433 PUKEHINA PARADE EASTERN

Land Information Memorandum

This determination is concerned with the compliance of repairs proposed to the external building envelope and considers whether the authority was correct to refuse to grant an amendment to the building consent. The determination also considers the authority's refusal to issue the code compliance certificate.

Figure 2: Locations of proposed repairs (not to scale)

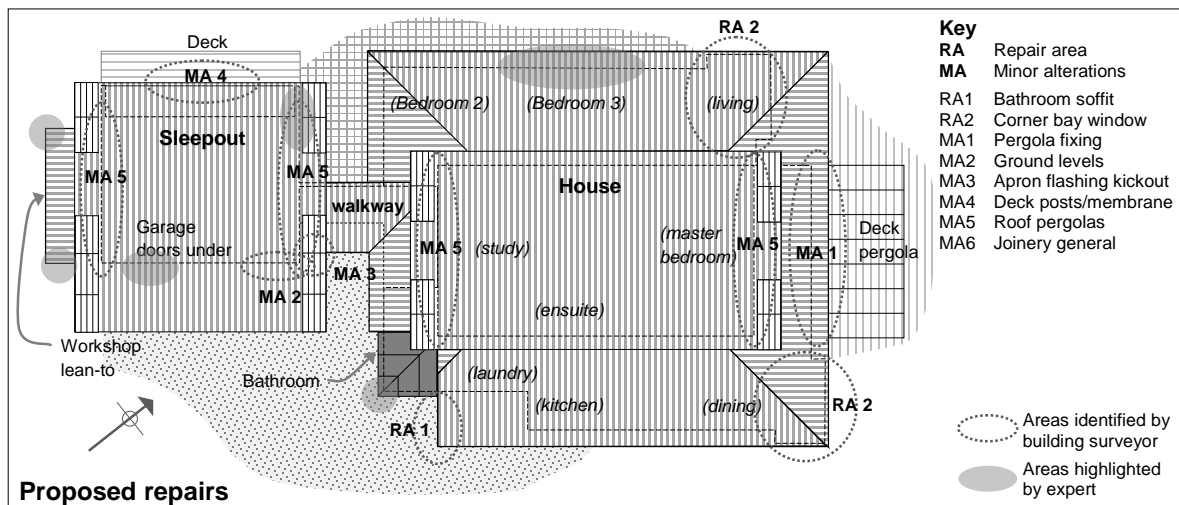
Areas of repair (see Figure 2)		Expert's comments	Expert's conclusion
RA1	Laundry soffit framing	<ul style="list-style-type: none"> • Lower plywood proud of upper • Framing to clad end of soffit decayed • No visible sign of damage to lower walls, but framing needs to be exposed to check 	Scope of proposed repair sufficient to address defect, but further investigation of the framing below the bulkhead is required to check for damage
RA2	Corner bay windows	<ul style="list-style-type: none"> • Cladding removed to expose framing • Framing below north window decayed • Framing below east window stained • No metal flashing under corner cladding • Battens were in poor condition, with tops exposed to rain penetration • Sill flashing detail still exposes batten tops • (I also note battens lack weathergrooves) 	Proposed details insufficient Further bay window and corner details required
MA1	Pergola to NE deck	<ul style="list-style-type: none"> • Pergola plate now spaced off cladding 	Satisfactory

Figure 2: Locations of proposed repairs (not to scale)

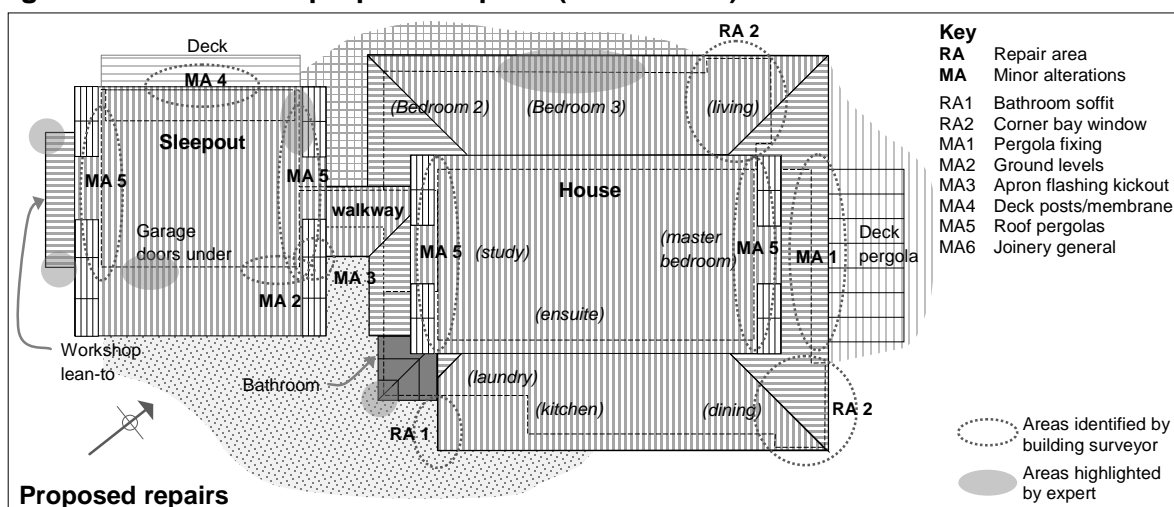
Areas of repair (see Figure 2)		Expert's comments	Expert's conclusion
RA1	Laundry soffit framing	<ul style="list-style-type: none"> Lower plywood proud of upper Framing to clad end of soffit decayed No visible sign of damage to lower walls, but framing needs to be exposed to check 	Scope of proposed repair sufficient to address defect, but further investigation of the framing below the bulkhead is required to check for damage
RA2	Corner bay windows	<ul style="list-style-type: none"> Cladding removed to expose framing Framing below north window decayed Framing below east window stained No metal flashing under corner cladding Battens were in poor condition, with tops exposed to rain penetration Sill flashing detail still exposes batten tops (I also note battens lack weathergrooves) 	Proposed details insufficient Further bay window and corner details required
MA1	Pergola to NE deck	<ul style="list-style-type: none"> Pergola plate now spaced off cladding 	Satisfactory

Photo 12: Bathroom at south corner of house. External corner cladding is at similar risk to boxed windows on NE elevation. Refer to photo 1 for location

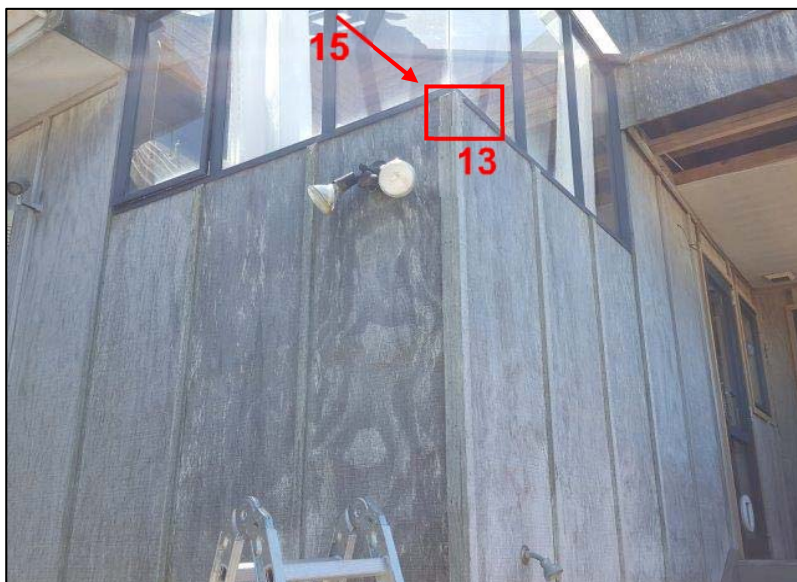
Photo 13: Bathroom external corner. The cover batten was loose and there are gaps in the building paper (indicated). The gap between the cladding sheets is larger than the 2-3mm expansion gap required by the manufacturer. No corrosion issues were noted with the cladding fixings. Refer next photo

Photo 14: Cladding cutout at external corner. No galvanised steel flashing was installed over the building wrap (recommended by BRANZ). Framing was dark and ants were present (indicating nearby moisture source), MC 9% normal moisture reading taken. Refer next photo for interior view

Photo 19: External corner junction at bottom plate, west corner of workshop. Refer following photo

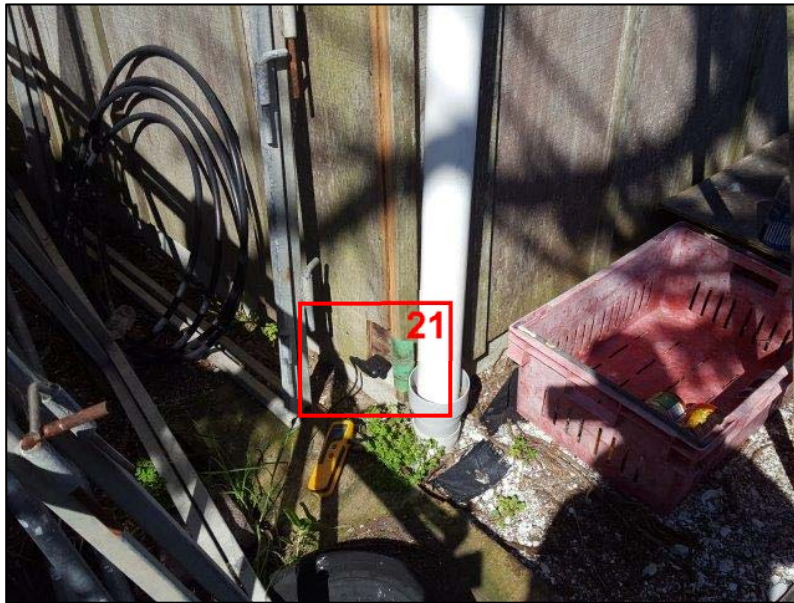
Photo 20: MC 21% elevated moisture reading at workshop external corner. Bottom plate is dark. No galvanised steel flashing was installed. Ground clearance is approximately 130mm from floor slab to unfinished ground level (225mm required to meet Acceptable Solution). Refer Dodd drawings (Minor Alterations 2)

Photo 26: Garage SE elevation. Refer following indicated photos

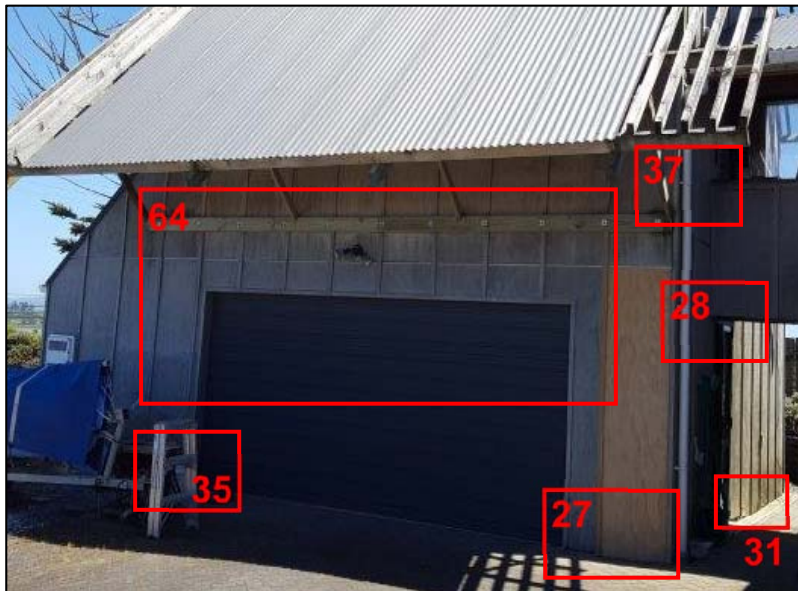
Photo 27: Plywood cladding has been replaced on SE garage elevation. Refer Dodd drawings (Minor Alterations 2). Ground clearances don't comply with drawings or meet Acceptable Solution. Refer Appendix C for photograph of bottom plate framing taken by builder. It appears the condition of the timber wasn't independently verified by the building surveyor

Photo 28: New cladding is fixed hard against garage slab. Dodd drawings specified existing framing to be straightened and packed out if required to provide 6mm clearance between cladding and concrete slab of garage. Note the cladding appears to be generally clear of the concrete slab elsewhere on the garage and workshop. Refer following photos

Photo 37: East corner of sleepout.
Refer next photo for closeup of apron flashing termination

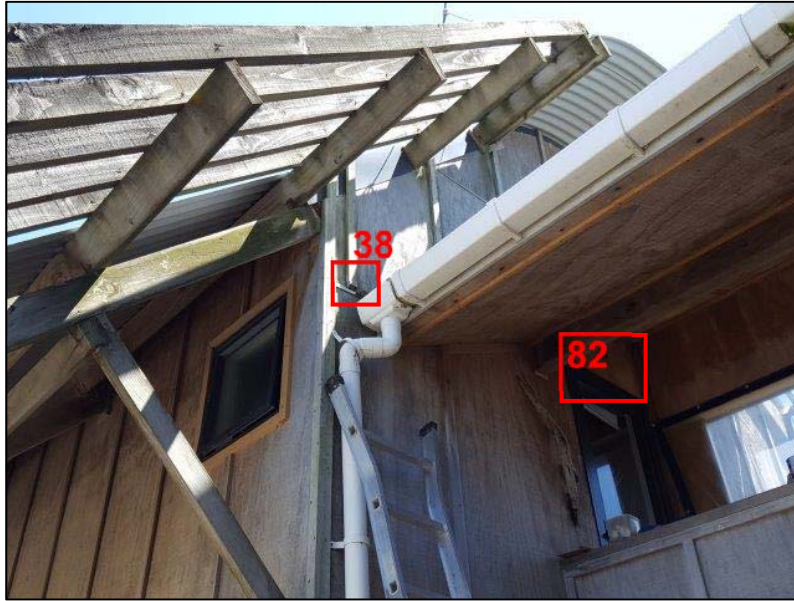
Photo 38: End of apron flashing terminates behind horizontal flashing. No kickout flashing is installed. Refer Dodd drawings for planned remediation (Minor Alterations 3)

Photo 39: Minimal cladding clearance to apron flashing at upper east corner of house. Difficult to maintain bottom edge of cladding but unlikely to result in weathertightness failure within prescribed 15 year durability period

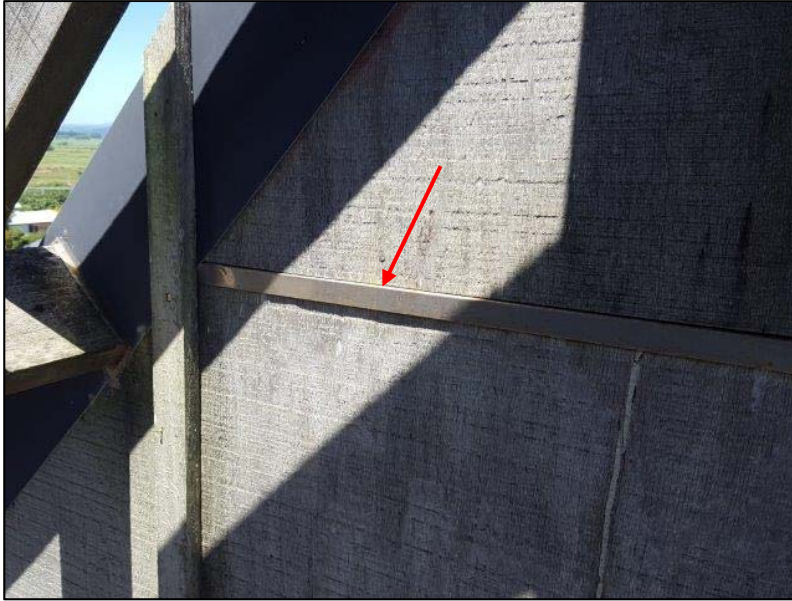
Photo 58: Plywood finished hard down on horizontal flashing. It is difficult to maintain the bottom edge of the cladding but unlikely to result in weathertightness failure (noting that the cladding has already performed for the prescribed 15 year durability period). There will however be an opportunity to correct the cladding detailing when plywood sheets are removed to install saddle flashings (refer Dodd drawings, Minor Alterations 5).

Photo 59: Horizontal flashing on NE beach elevation has been battened and partially sealed. It is unclear whether the sealant was added as a preventative measure or if the cladding was leaking. Also refer next photo and photo 50 for location

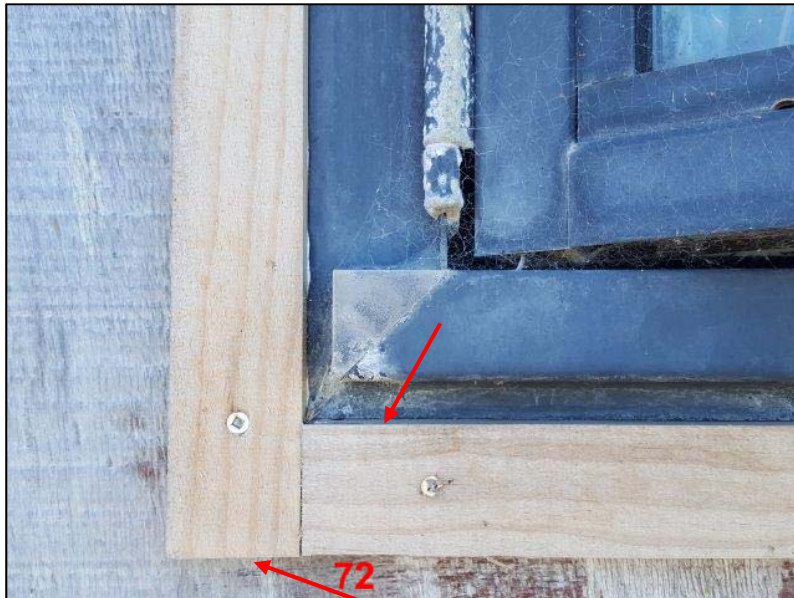
Photo 71: New jamb and sill timber trims installed to bifold window. Flat top surface allows water to pond on sill trim, potentially trapping water against the cladding and restricting drainage from behind the window flange. The Dodd drawings (Minor Alterations No. 6) dated 3.08.16 called for jamb sealant to be renewed and covered with new battens to sides of all joinery. It appears the sill trims may have been installed prior to these drawings being issued. Refer next photo from below trim.

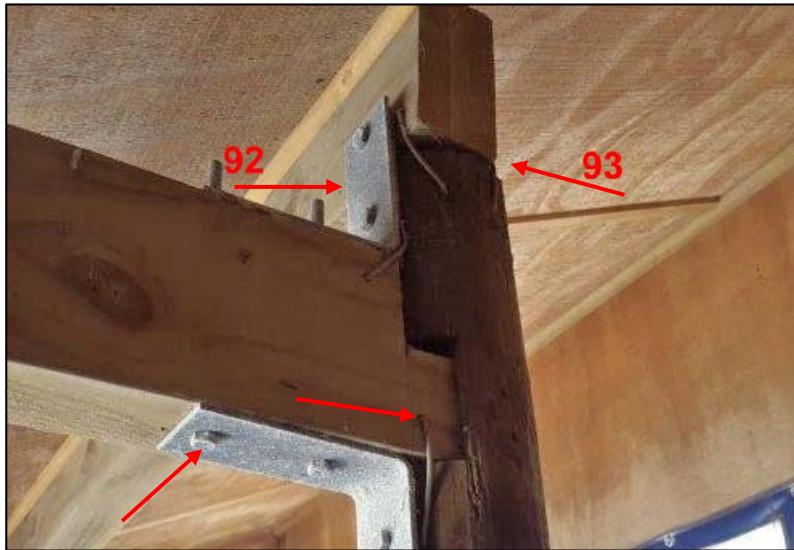
Photo 92: Top beam connection to timber pole is reliant on a single bolted connection and four wire dogs, all in the end and lower third of the beam. The connection could be improved significantly by installing a longer bracket with double bolted connection to the top beam. Refer next photo at other end of the single bolted connection

Photo 93: Top beam connection to timber pole is reliant on a single bolted connection and four wire dogs, all in the lower third and close to the end of the beam. The connection is required to perform for the life of the building (i.e. minimum 50 years). The adequacy of the connection is questionable in a major seismic or storm event
